HISTORIC AND DESIGN REVIEW COMMISSION

October 07, 2020

HDRC CASE NO: 2020-431
ADDRESS: 109 CANAL ST
LEGAL DESCRIPTION: NCB 924 BLK 5 LOT S 43 FT OF 7 & S 46 FT OF E 12 FT OF 6
ZONING: RM-4, H
CITY COUNCIL DIST.: 1
DISTRICT: Lavaca Historic District
APPLICANT: Martin Lopez/LOPEZ MARTIN & MARIA
OWNER: Martin Lopez/LOPEZ MARTIN & MARIA
TYPE OF WORK: Window replacement
APPLICATION RECEIVED: September 15, 2020
60-DAY REVIEW: Not applicable due to City Council Emergency Orders
CASE MANAGER: Huy Pham

The applicant is requesting a Certificate of Appropriateness for approval to replace 10 wood sash windows with new vinyl windows.

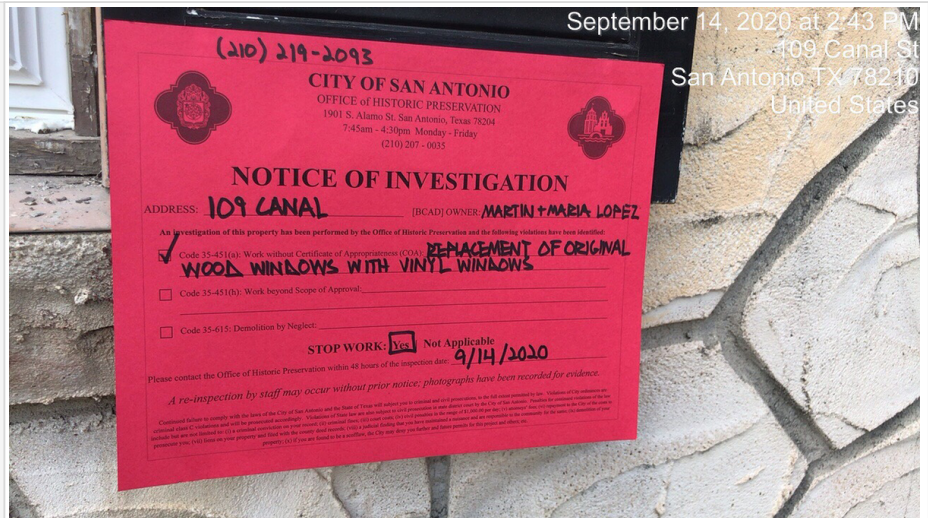
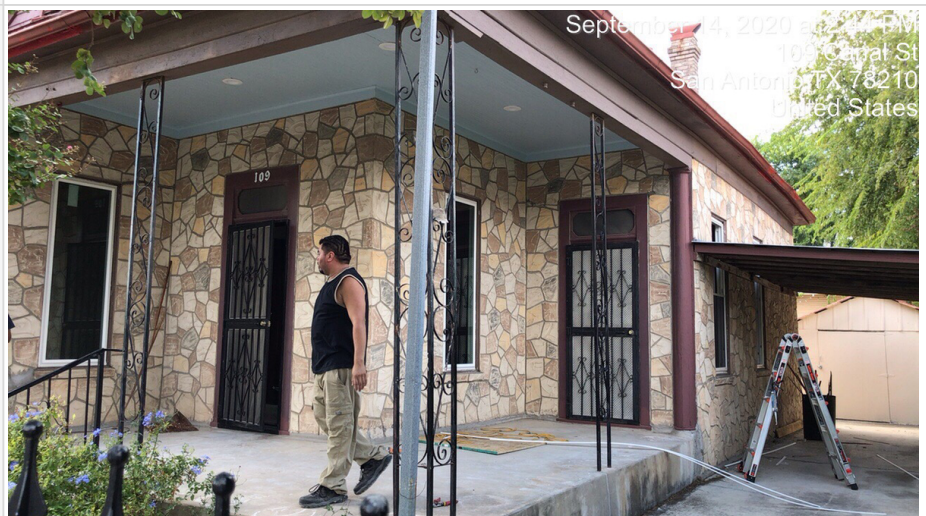
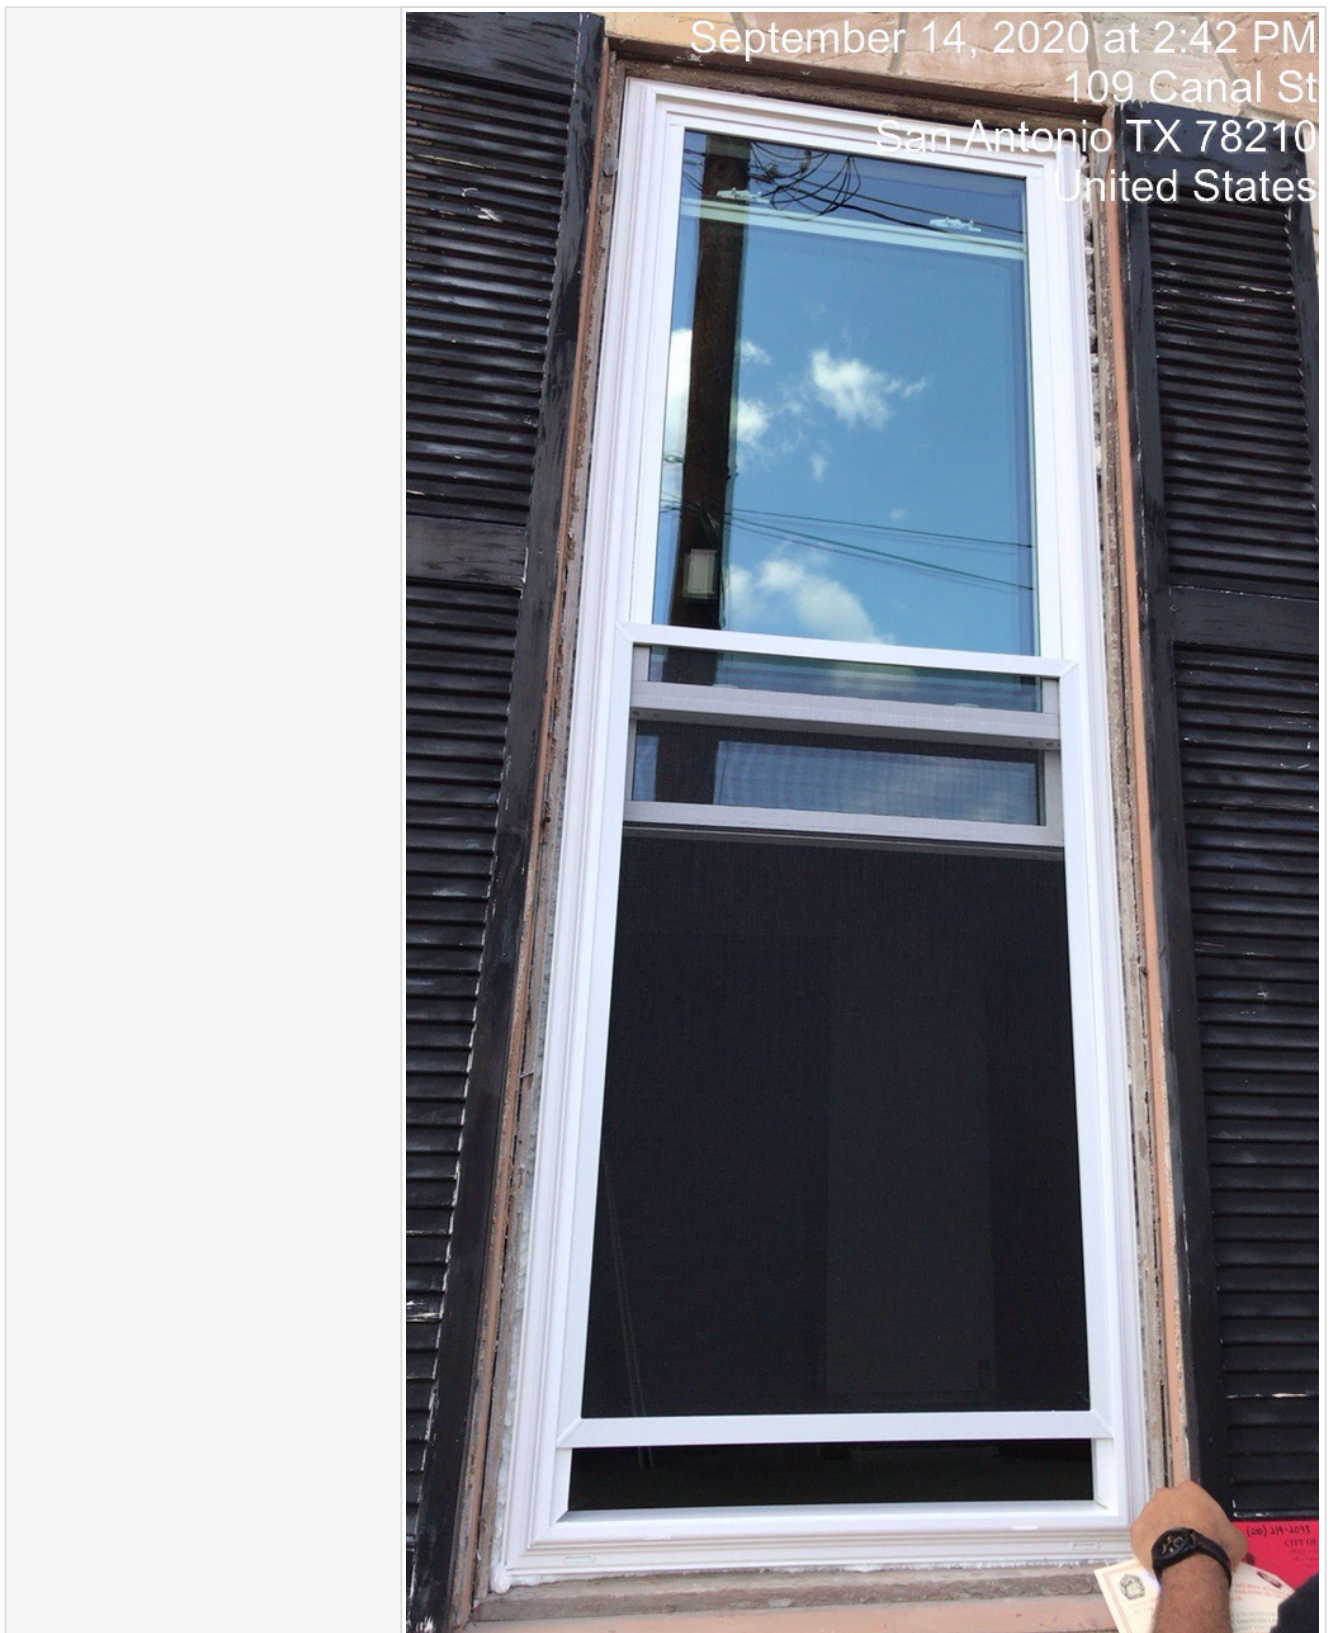
- b. COMPLIANCE -On a site visit conducted on September 14, 2020, staff found that the property at 109 Canal was subjected to window replacement prior to approval. Staff advised the contractors on-site to store and not discard any of the wood windows prior to a commission action. The contractors and applicant were cooperative with the Stop Work Order and submitted an application on September 15, 2020, to be heard at the next Historic and Design Review Commission hearing.

- c. WINDOW REPLACEMENT – The applicant has proposed to replace all 10 two-over-two, wood sash windows with new one-over-one, vinyl windows of approximately the same size. Per the Guidelines for Exterior Maintenance and Alterations 6.B.iv., applicants should install new windows to match the historic or existing windows in terms of size, type, configuration, material, form, appearance, and detail when original windows are deteriorated beyond repair. The proposed vinyl windows are not consistent with the Guidelines. Additionally, during the site visit conducted on September 14, 2020, staff found the existing sashes to be in good condition. Staff finds that the existing wood sashes should be repaired and re-installed.

Date	09/14/2020
Time	02:45 PM (-5 GMT)
Context	citizen report
Present Staff	Huy Pham, Edward Hall
Present Individuals	Contractor(s)
Contractor/Realtor Companies	Champion Window (unassociated subcontractors)
Types of Work Observed	Exterior Maintenance and Alterations
Amount of Work Completed	Completed
Description of work	Replacement of up to 10 wood windows with sashes visible on site.
Description of interaction	Subcontractors were cooperative to the Stop Work Order and committed to storing the windows inside until the homeowner/project manager submits an application.

Staff does not recommend approval of window replacement based on findings b through c. The removed, wood windows should be repaired and reinstalled.
